I-405 MP 26.90 Queensborough Creek (WDFW ID): 993109 Final Hydraulic Design Report – NDC 152

**Yacoub Raheem, PE, Water Resources Engineer
WSDOT Fish Passage and Stream Restoration Design Certification #FPT20-18166
WSDOT Scour Certification #SCR23-08666
AECOM Portland, OR**

This notice of design change (NDC) modifies the I-405 MP 26.90 Queensborough Creek Final Hydraulic Design Report (FHD). It presents updated bed material gradations and updated scour analyses associated with this change. This report addendum supersedes and replaces the following tables, sections, and figures as specified below.

Figure 4-2: Typical riffle design cross section

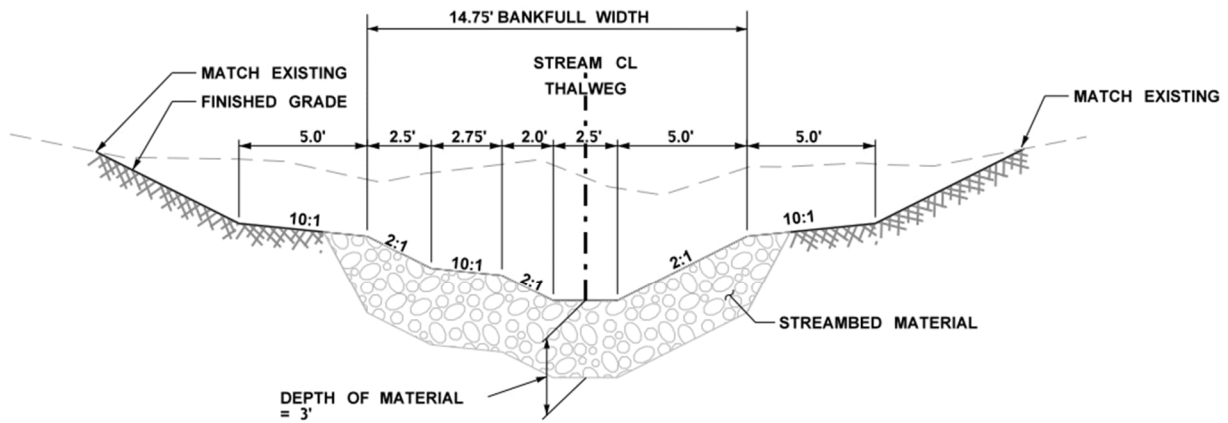
- Updated Figure 4-2 and Figure 4-3.
- Section 4.2 Minimum Hydraulic Opening
 - Updated Figure 4-4.
 - Section 4.2.4 Hydraulic Length updated to include reference to DBIC 049 and discuss the updated hydraulic length.

For Queensborough Creek, the proposed channel design follows a meandering pool-riffle morphology. The design proposes variability in the vertical and cross-sectional shape for distinct riffles and pools, as shown in the geometries associated with riffle and pool typical cross sections. The instream habitat configurations include slopes that mimic existing channel geometry to the extent feasible, as shown in the figures below. **Figure 4-1** superimposes the proposed riffle cross section with existing terrain cross sections upstream and downstream of the crossing. The section shown in **Figure 4-2** has been developed for use in riffle sections, and **Figure 4-3** shows a typical pool section.

Cross slopes in riffles are 8H:1V to promote fish passage in low flows with 2H:1V bank slopes extending to the bankfull width of 10.1 feet. The typical pool section has a wider bankfull width to achieve acceptable residual pool depths. Typical pools are pre-scoured and are not anticipated to scour significantly deeper than the as-built condition as indicated by minimal calculated bend scour depths in **Section 7.4.3**. Typical pool sections also include a 10H:1V bench on the inside of meander bends to mimic the formation of point bars (Cramer 2012). The average meander spacing is approximately four times the bankfull width, consistent with Project Technical Requirements.

Figure 4-4: Illustration of minimum hydraulic opening and structure free zone

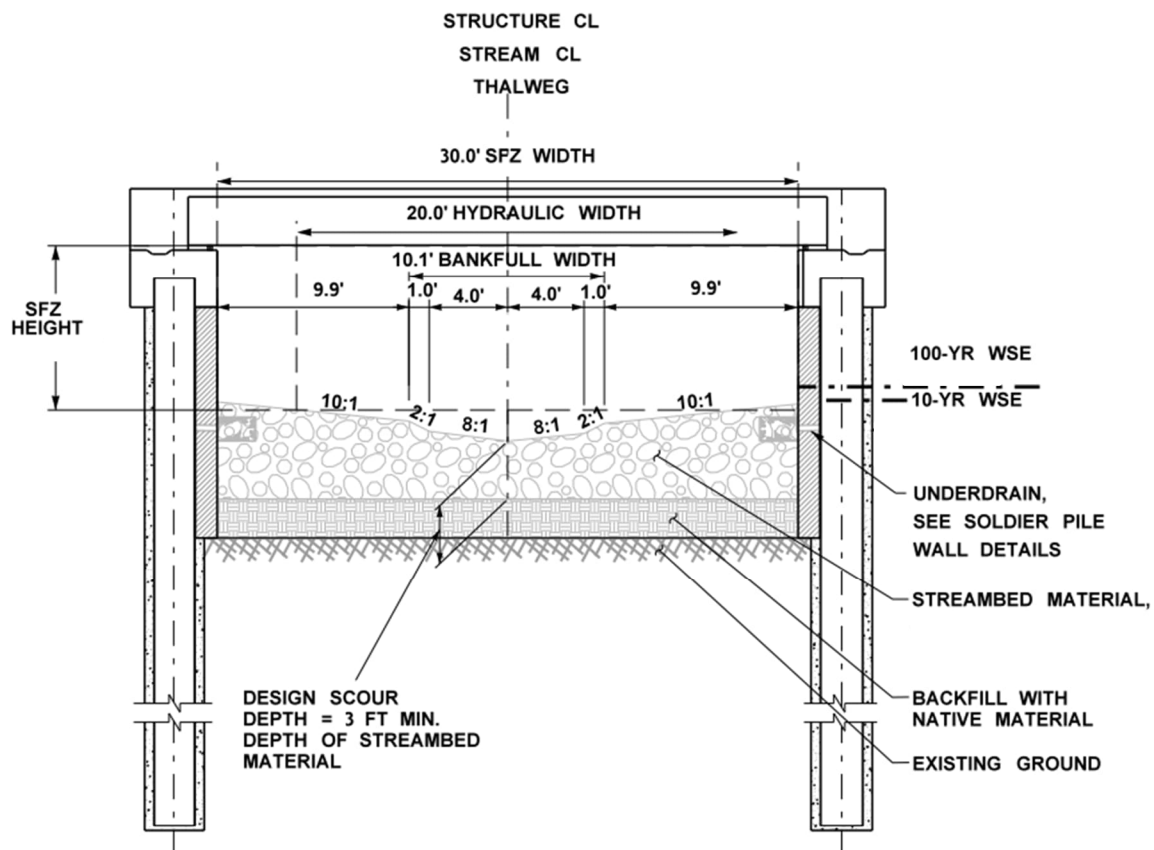
Because the hydraulic length has increased since the preliminary design, the hydraulic width and vertical clearance should be reevaluated. Based on the stream's bankfull width of 10.1 ft, Equation 3.2 of the WDFW 2013 Water Crossing Design Guidelines, and the fact that this crossing is defined as a "long culvert" by WDFW, the minimum hydraulic width was determined to be 20.0 ft. Proposed geomorphic features including large woody material, mobile woody material, and meander bars will be placed in the structure to provide habitat complexity and diversity. Considering the addition of these geomorphic features, a 30-foot structure free zone width was determined for the site.

The wingwall configuration allows for greater than a 30-foot structure free zone width outside of the structure, therefore, the stream will not be confined through the wingwalls. The width of flow during the 2-year storm (a proxy for the dominant channel forming flow) is not confined within the structure or wingwall layout.

Figure 4-5: Downstream layout of habitat complexity features

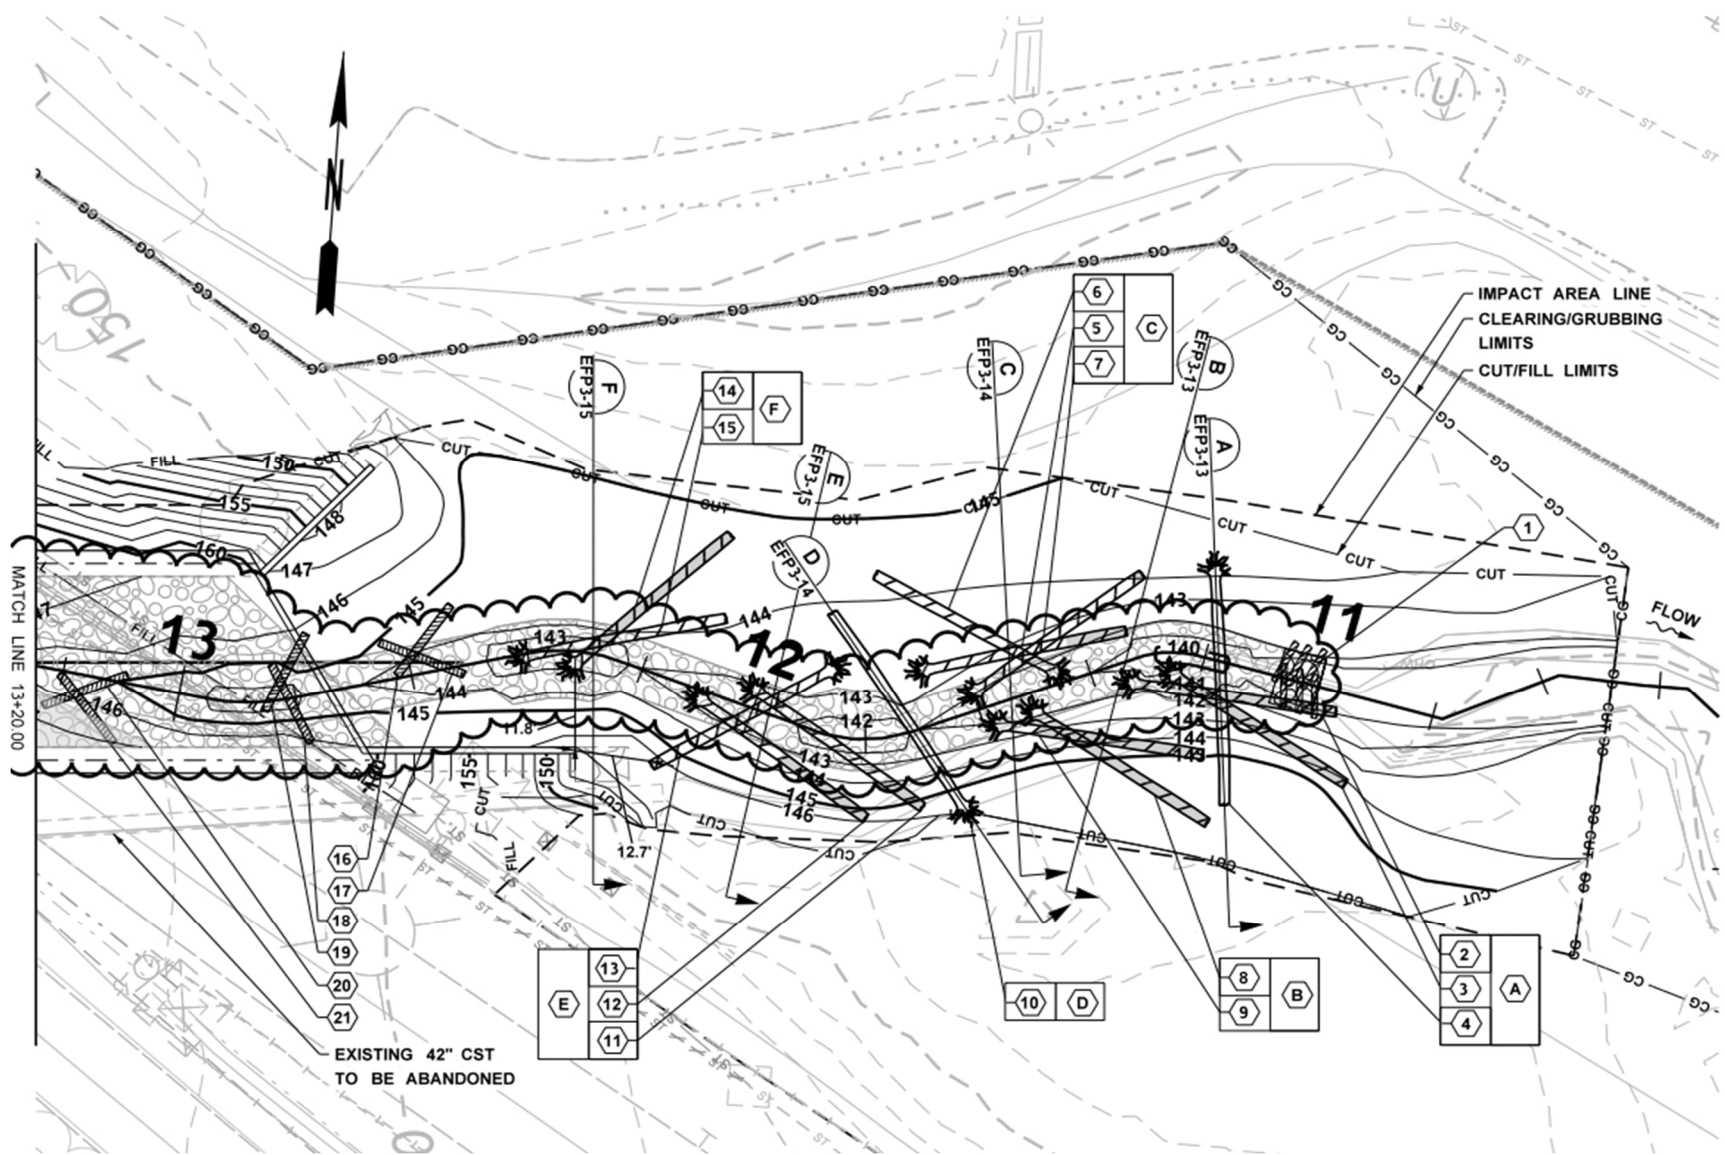
- Section 4.3.2 Channel Complexity
 - Subsection 4.3.2.1 Design Concept, Figures 4-5, 4-6, and 4-7 revised.
 - Subsection 4.3.2.3 Meander Bars revised to remove reference to previous Type II Streambed Material and discuss meander bar material gradation.

The three channel complexity elements will be incorporated into the channel design to meet the functional goals, as described in more detail in the following subsections and seen in **Figure 4-5, Figure 4-6, and Figure 4-7** (see **Appendix D**).

Figure 7-3: Location of meander bends evaluated for bend scour

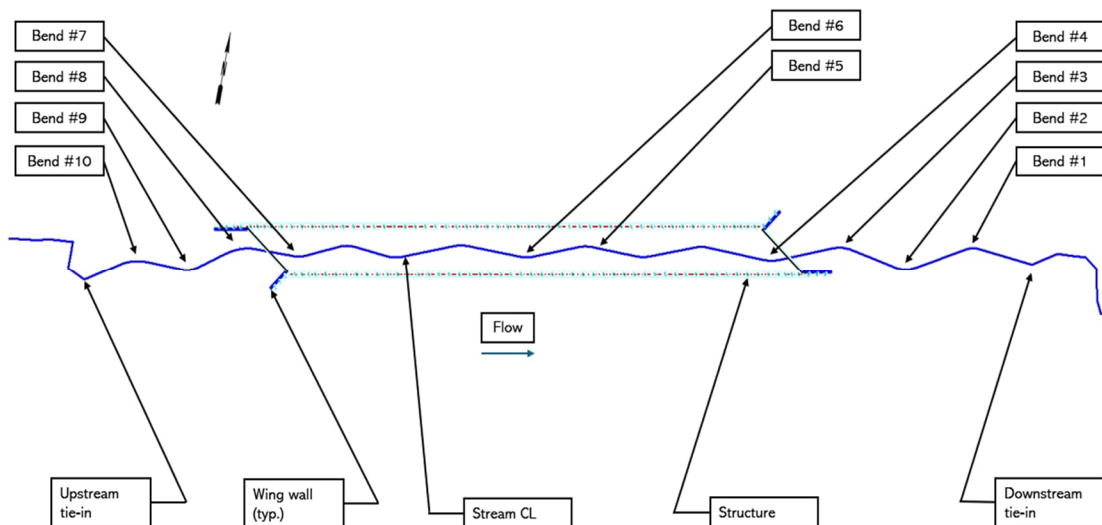
- Subsection 7.4.3 Bend Scour revised.
- Section 7.5 Total Scour
 - Updated total scour values in text.
 - Updated Table 7-2.
- Section 9 Summary
 - Updated Table 9-1 potential channel degradation value.

The bend scour equations used are empirical and were developed based on flows at or below the bankfull condition and are generally valid up to significant interaction between main channel and overbank flows (USACE 2025; WDFW 2012). Due to this, bend scour was evaluated using the 2-year flow. **Figure 7-3** shows the location of the bends analyzed.

However, the proposed channel will have pre-scoured pools that dissipate hydraulic energy, resulting in a 1.0-foot residual pool depth at every meander bend. The estimated maximum bend scour, beyond the 1.0-foot residual pool depth, is 0.8 feet.
